Re. : FMVSS Standard 573 - Defect and Noncompliance Responsibility and Reports
Alternator B+ cable - Van Hool Model C2045

NHTSA ODI Resume - Investigation PE 08-003

Safety Defect and Noncompliance Report Guide for Vehicles PART 573 Defect and Noncompliance Report¹

SB1210A

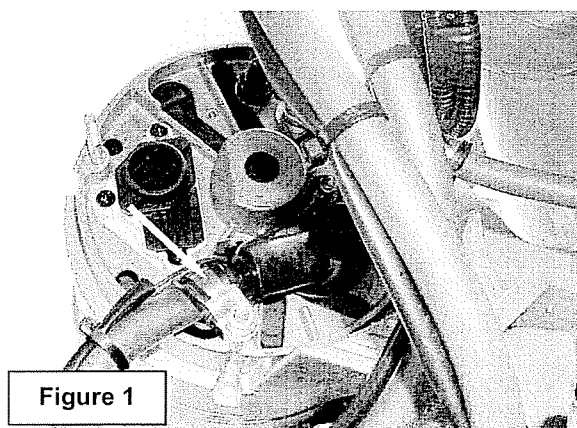
1. It has been determined that on the above-mentioned units a possible defect may exist which relates to motor vehicle safety.
As a result of vibration the B+ alternator cable retention may fail through breakage of the B+ ring terminal. The positive battery cable detaching from the rear of the alternator could result in a loss of battery charging capability or cause a short-circuit and even start a fire.
2. To address these issues in production, a P-clamp is now fitted below the black PVC terminal cover in order to improve cable retention and ensure the service life of the terminal (Figure 1). This modification has been introduced on both the upper most and lower most mounted alternators as from Commuter Coach # 47448.

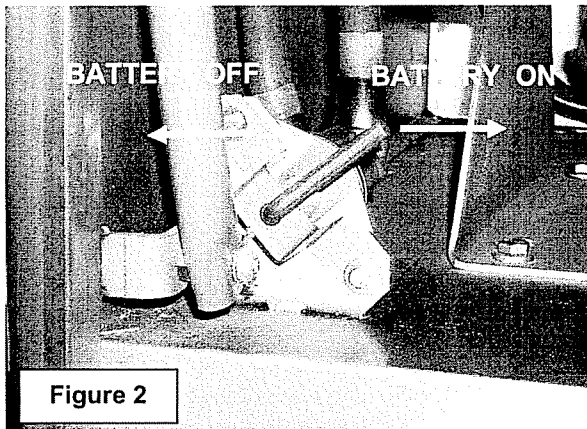
CAUTION: Before working on the alternator B+ cables turn off the battery disconnect switch in the battery compartment (Figure 2).

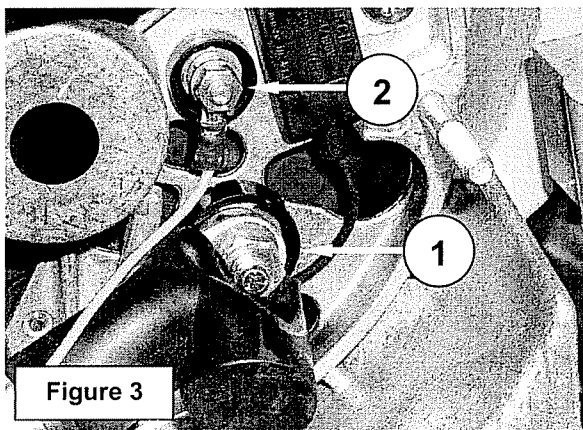
Undo the nut securing the terminal (1, Figure 3).

Undo the nut securing the D+ terminal (2, Figure 3).

Cut cable ties as required to allow re-routing of the B+ and D+ cables.

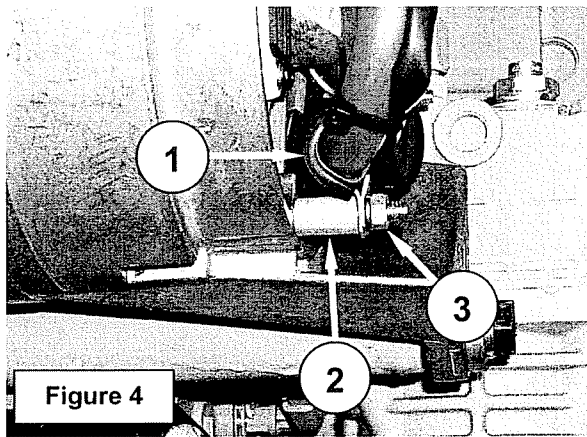
- 3) Referring to Figure 4, slip a P-clamp over the cable (1).
Install a spacer bushing over the lower most stud (2).
Install the P-clamp over the stud.
Install the lock washer and nut (3).
Adjust the cable routing for a stress-free installation.
Tighten the clamp nut to a torque of 80 in.lbf (8.6 Nm).

Tighten the B+ terminal nut to a torque of 80 to 115 in.lbf (9 to 13 Nm).
Tighten the D+ terminal nut to a torque of 21 to 28 in.lbf (2.4 to 3.2 Nm).
Re-secure the B+ and D+ cables with cable ties.

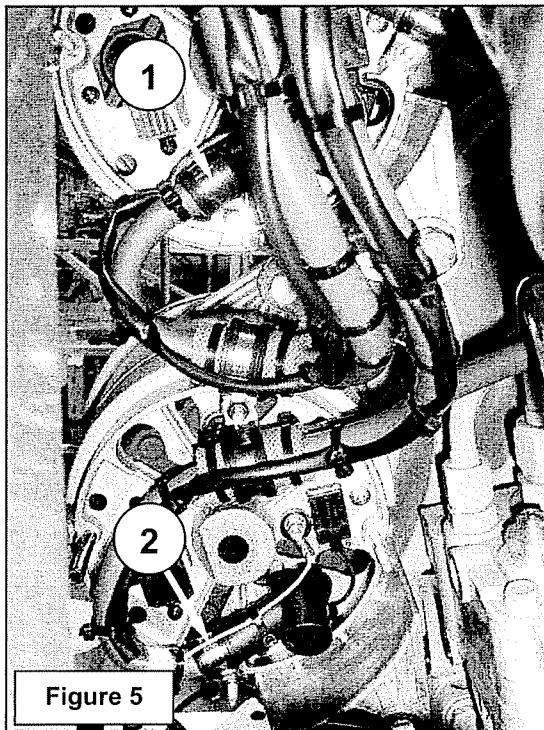
- 4) Repeat steps 1 and 2 for the lower most alternator.
- 5) Referring to Figure 5, check the cable routing to be compliant to the one shown. Adjust as necessary.
- 6) Turn on the battery disconnect switch.
